Michigan Department of Environment, Great Lakes, and Energy
Wolverine CAG – Draft Tannery Interceptor System Response Activity Plan

The Wolverine Community Advisory Group (WCAG) is comprised of concerned citizens that have been impacted by PFAS contamination from the Wolverine World Wide (WWW) Tannery (Tannery) in Rockford and their waste disposal sites in northern Kent County. The contaminated area covers approximately 25 square miles and PFAS compounds have been detected in 800+ residential wells and the Plainfield Township municipal water supply which serves over 40,000 people. The WCAG is responding to the Draft Tannery Interceptor System Response Activity Plan (Interceptor Plan) by Wolverine World Wide (WWW), Inc. The Interceptor Plan was submitted as a requirement of the Consent Decree (CD), effective February 19, 2020, presented for public comment on April 22, 2021.

Figure 1. Groundwater concentrations of PFAS at the WWW Tannery site (Figure 2.3 from Tannery Interceptor System Response Activity Plan).

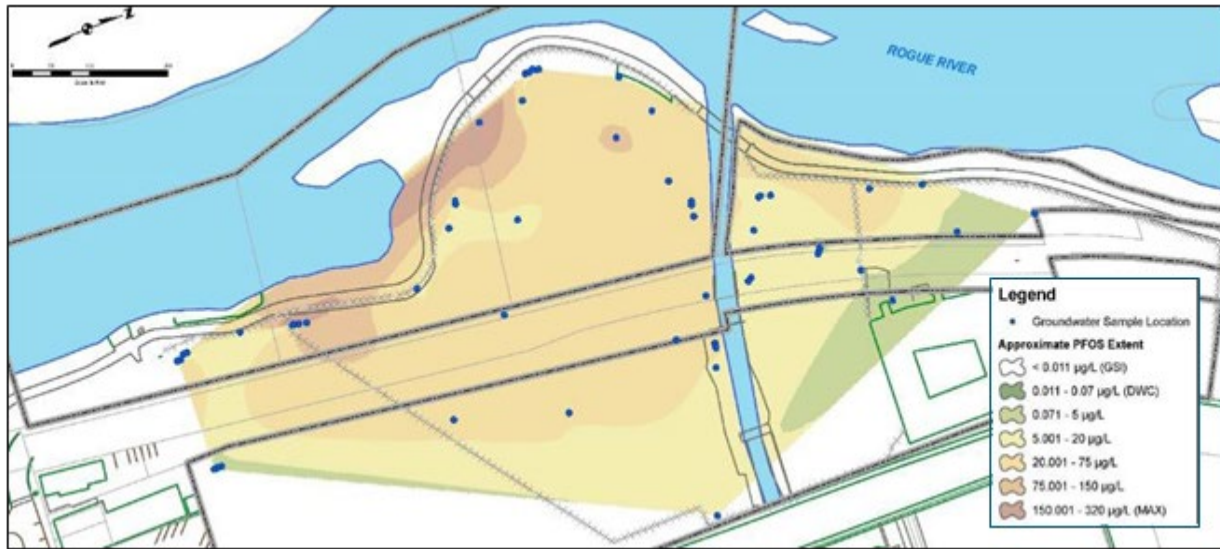
System document to be inadequate. In addition, it is inconsistent with the requirement of the Consent Decree (CD), which states, "... The system expansion shall be appropriately sized to address and control PFAS compounds contamination in groundwater at the Tannery before it enters the Rogue River." While the piezometers will show drawdown of the water table at specific points, the most direct and effective way to monitor system performance is through testing of compliance wells down gradient of the extraction system and monitoring of PFAS loading

reductions in the Rogue River and Rum Creek. The extent of PFAS contamination in the groundwater is shown in Figure 1 and the location of the proposed extraction wells are shown in Figure 2. Based on these figures, there are existing monitoring wells that can be sampled or new ones that can be installed in the area between the extraction well array and the Rogue River that can be used to monitor and ensure compliance with CD requirement to "address and control PFAS compounds contamination in groundwater at the Tannery before it enters the Rogue River."

Figure 2. Location of the extraction wells.

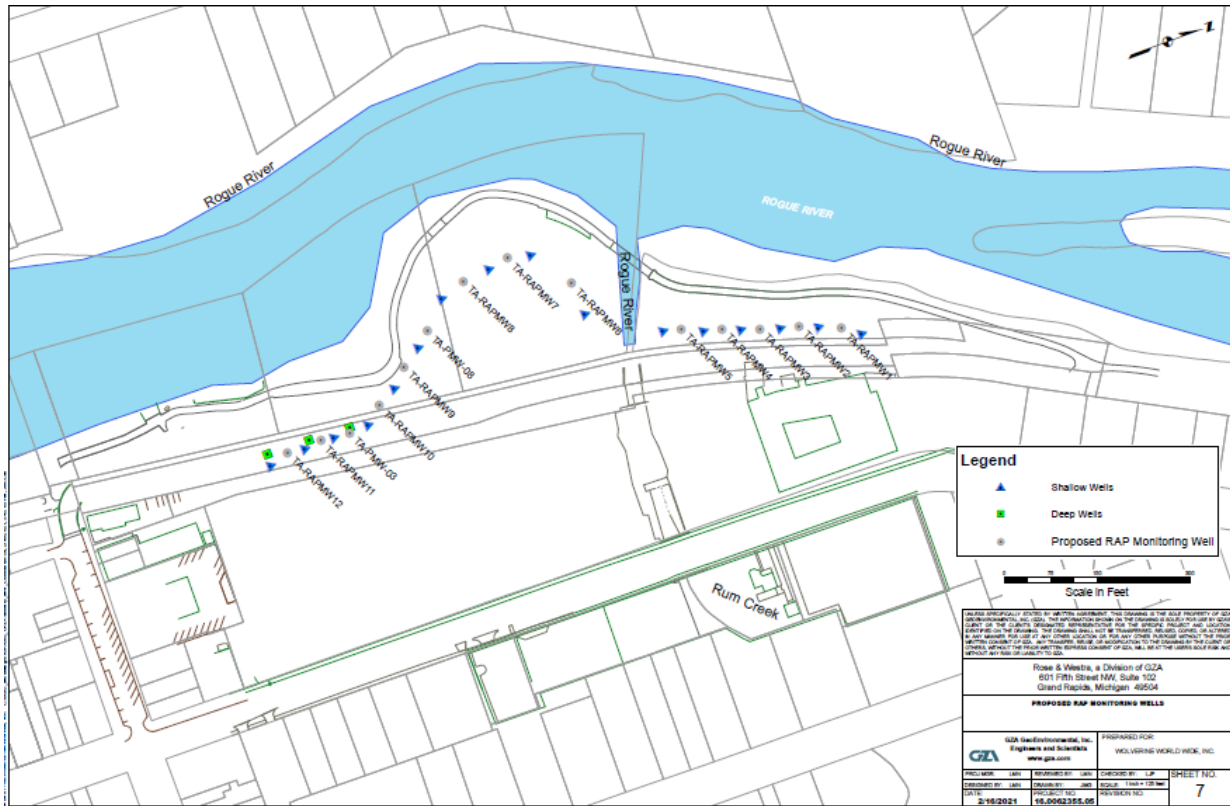
In fact, the most direct way to demonstrate compliance with the requirement to “control PFAS compounds contamination in groundwater at the Tannery before it enters the Rogue River” is to sample the Rogue River upstream and downstream of the Tannery for PFAS compounds and with discharge data, calculate the loading of PFAS compounds in the river. If the treatment system is effective, there should be no increase in loading between and up and down gradient sampling locations.
